ADDENDUM NUMBER ONE

DARLA MOORE SCHOOL OF BUSINESS CONSTRUCTION – BP-3
ENCLOSURE/SITE/MEFP/INTERIOR
UNIVERSITY OF SOUTH CAROLINA
STATE PROJECT NUMBER H27-6069-AC-3

DATE OF ISSUE: June 04, 2012

ENLARGED SECTION, ELEVATION, & PLAN - EXTERIOR GUARD/HANDRAIL- GR-1
REF. DWG # 01 & 02/A4802.1
SHEET TITLE :

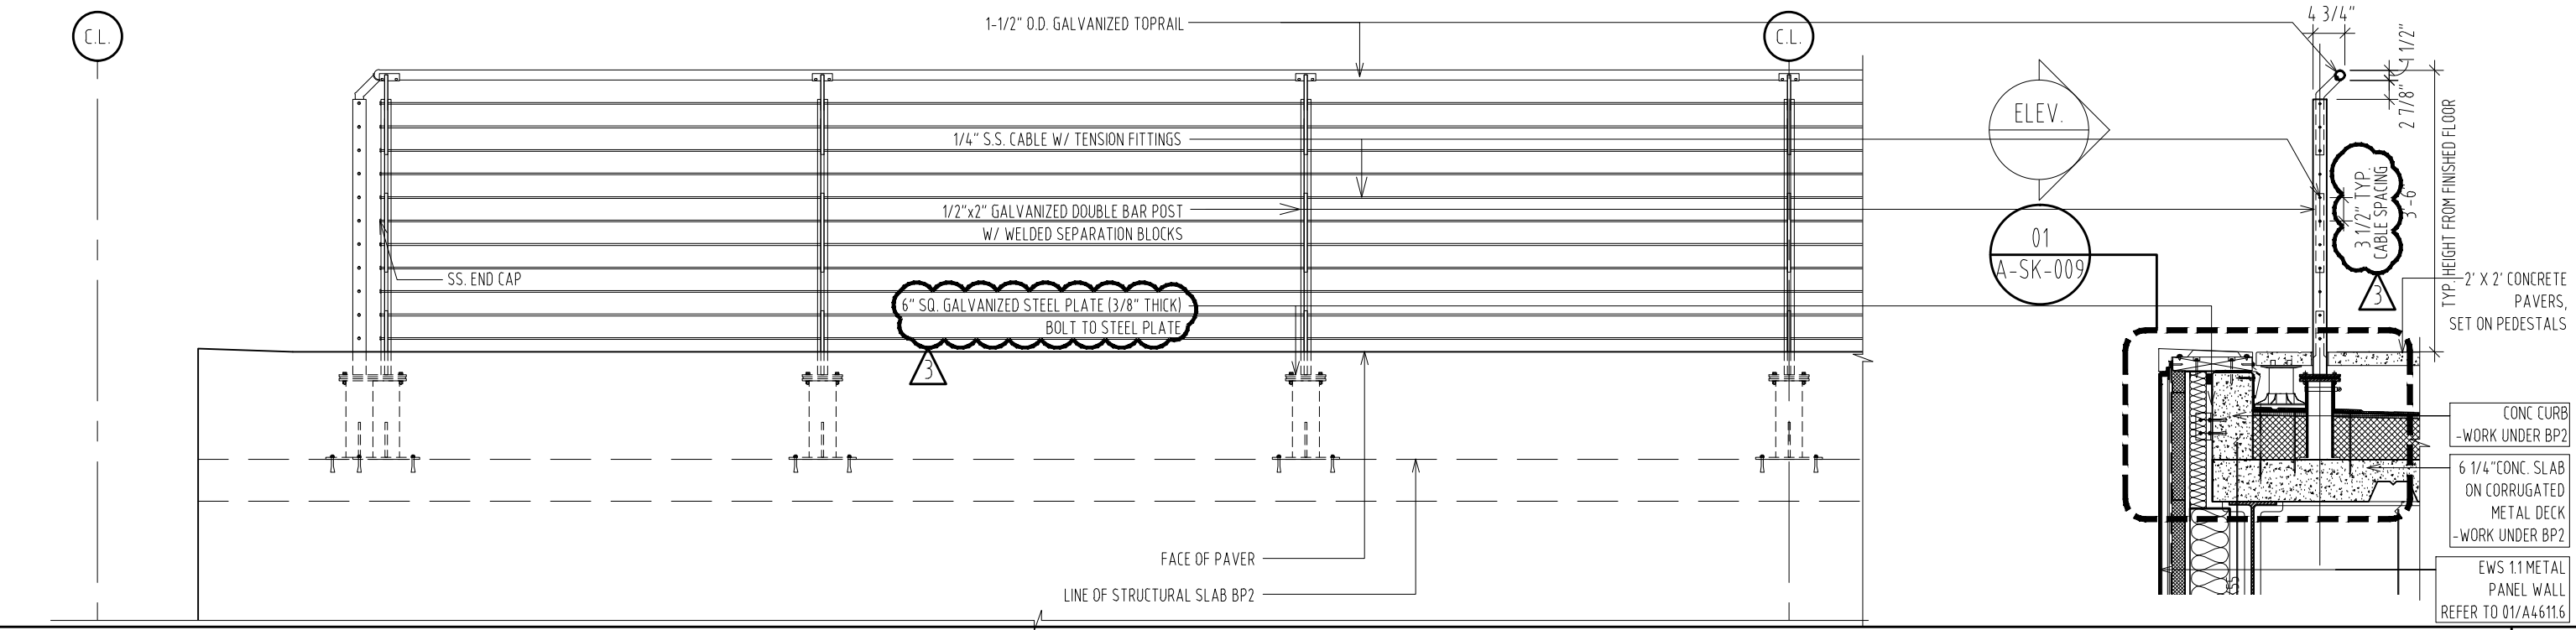
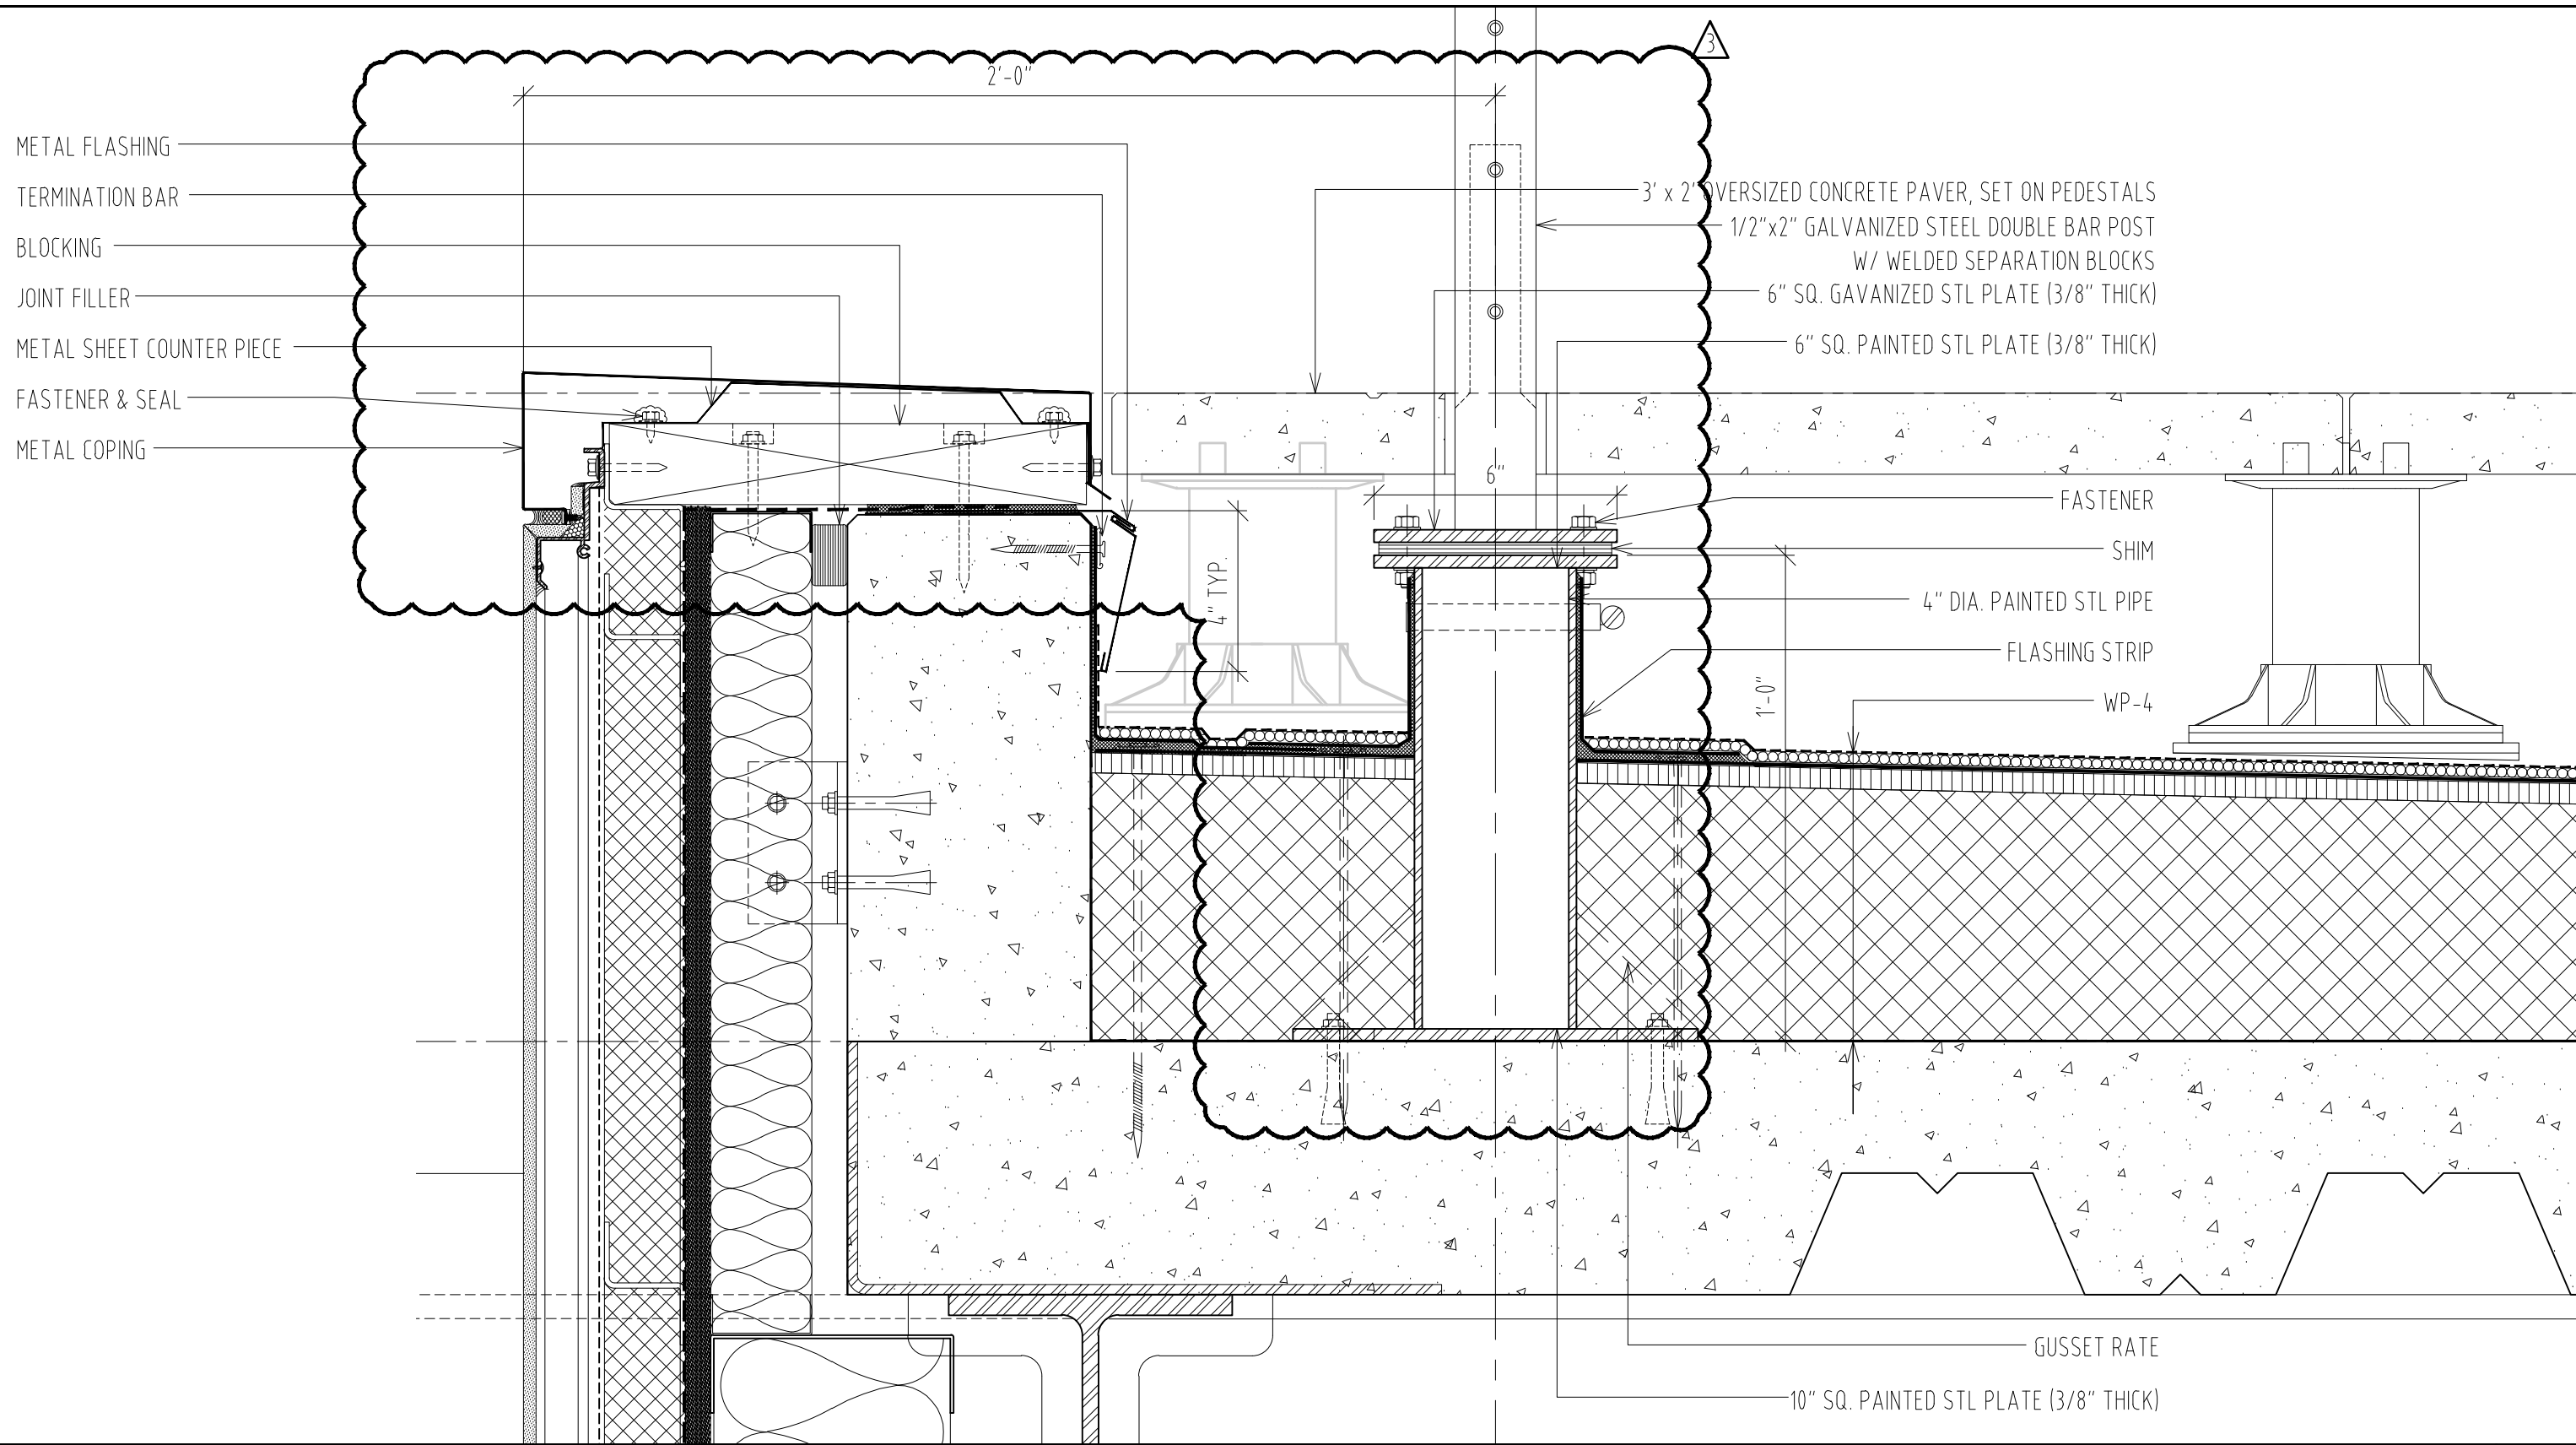
7.	Detail Sheet A4802.1, A3301, A3302, A3303, A3304, A3305, A3306, A4611.6: Refer to attached sketch A-SK-008 and A-SK-009. Revised guardrail type 1 (GR-1) post connection to deck instead of parapet. Revised post spacing. Revised horizontal cable spacing.

CHANGE OF GLAZING TYPES AT LEVEL 4 PERIMETER - EAST ELEVATION
REF. DWG # A2201
SHEET TITLE :

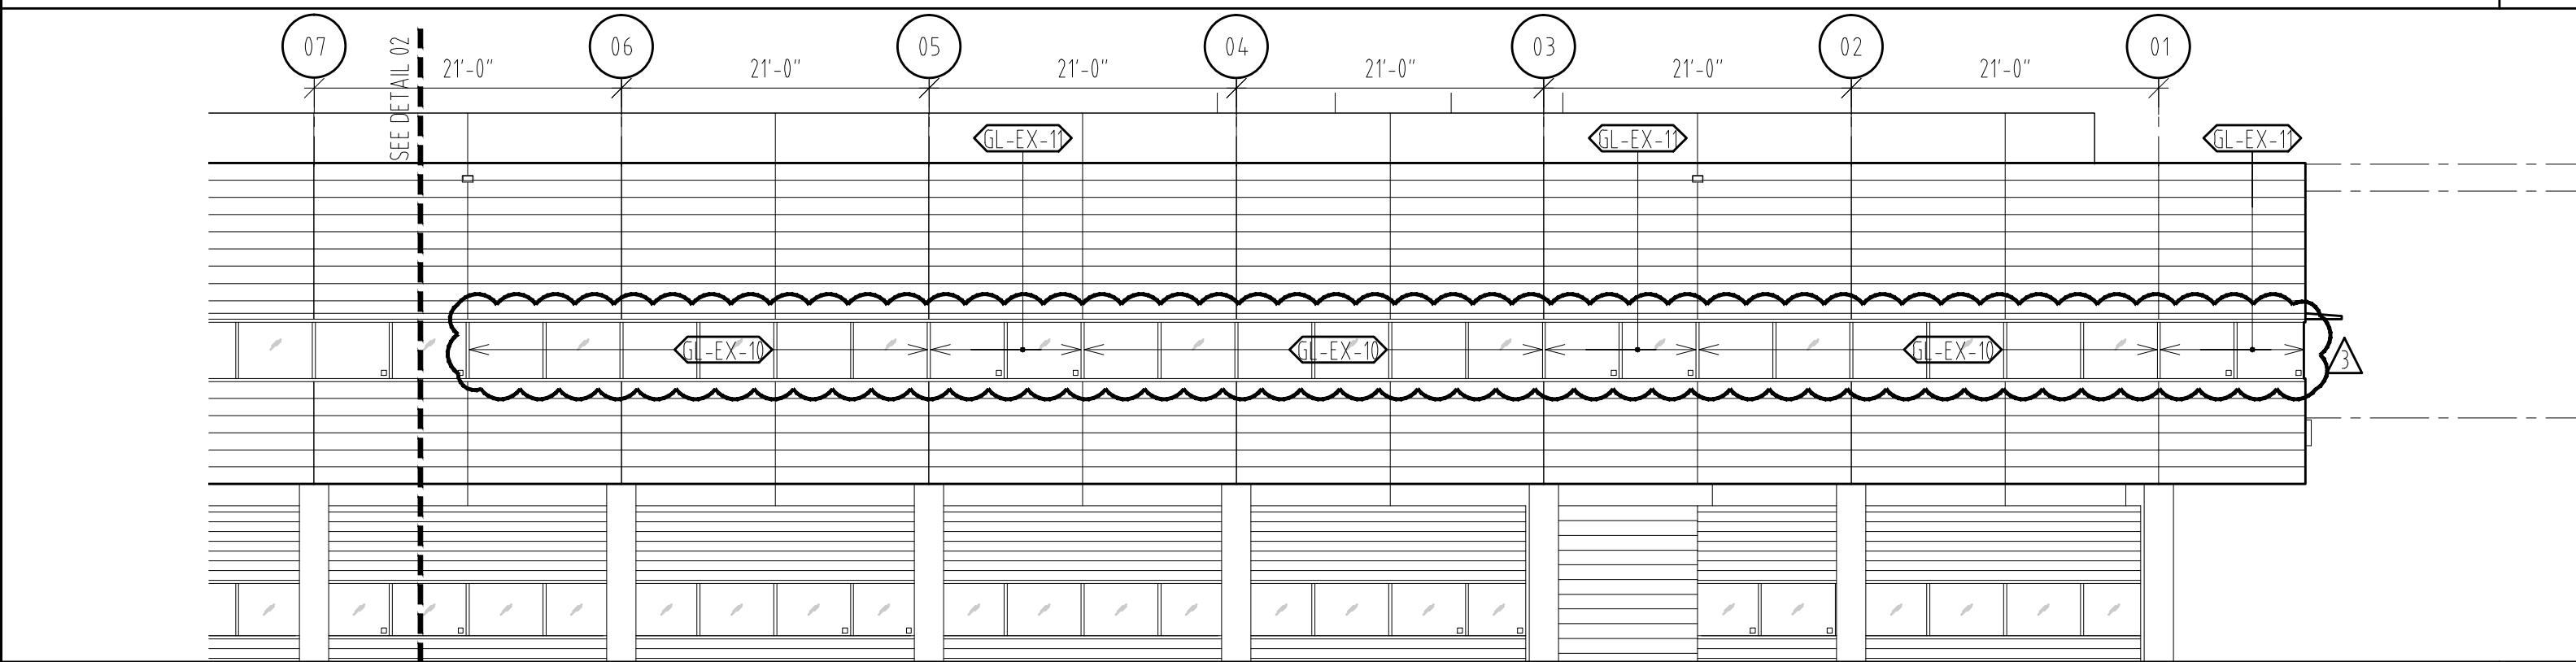
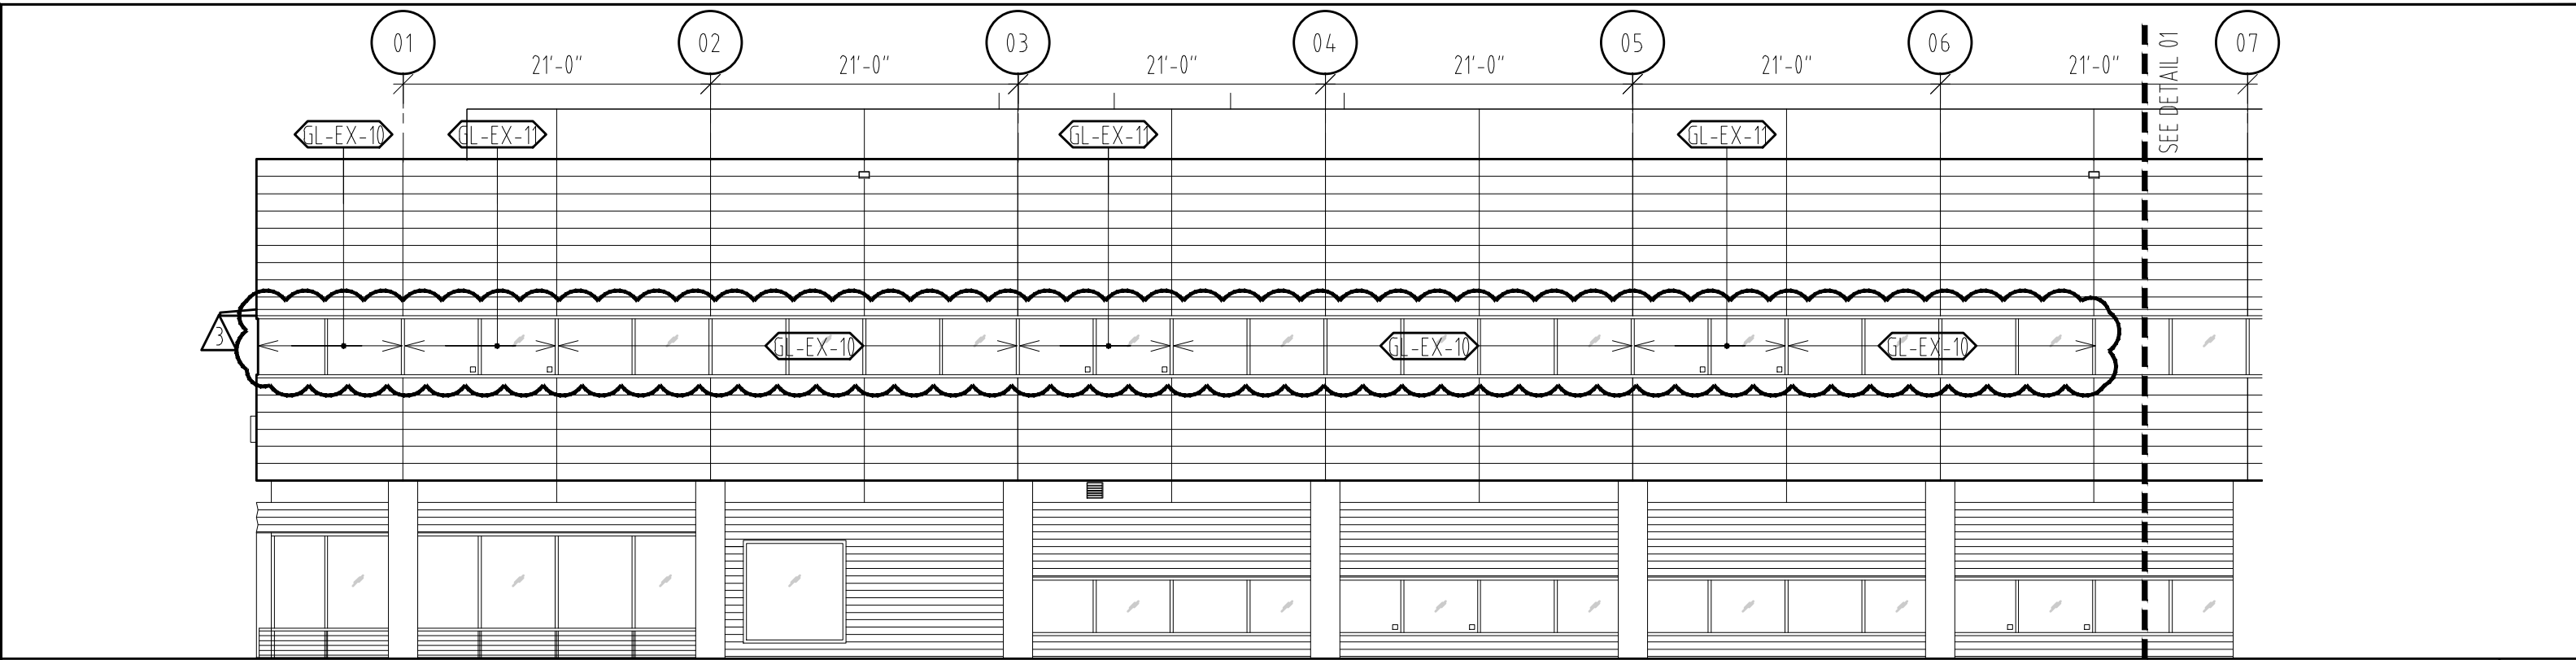
8.	Elevations Sheet A2201, A2221, A2222, A2231, A2232, A2202, A3304, A3305, A3306 and Glazing Schedule A4602: Refer to attached sketch A-SK-010, A-SK-011, A-SK-012, A-SK-013, and A-SK-014. Revisions to exterior glazing type at Level 4.
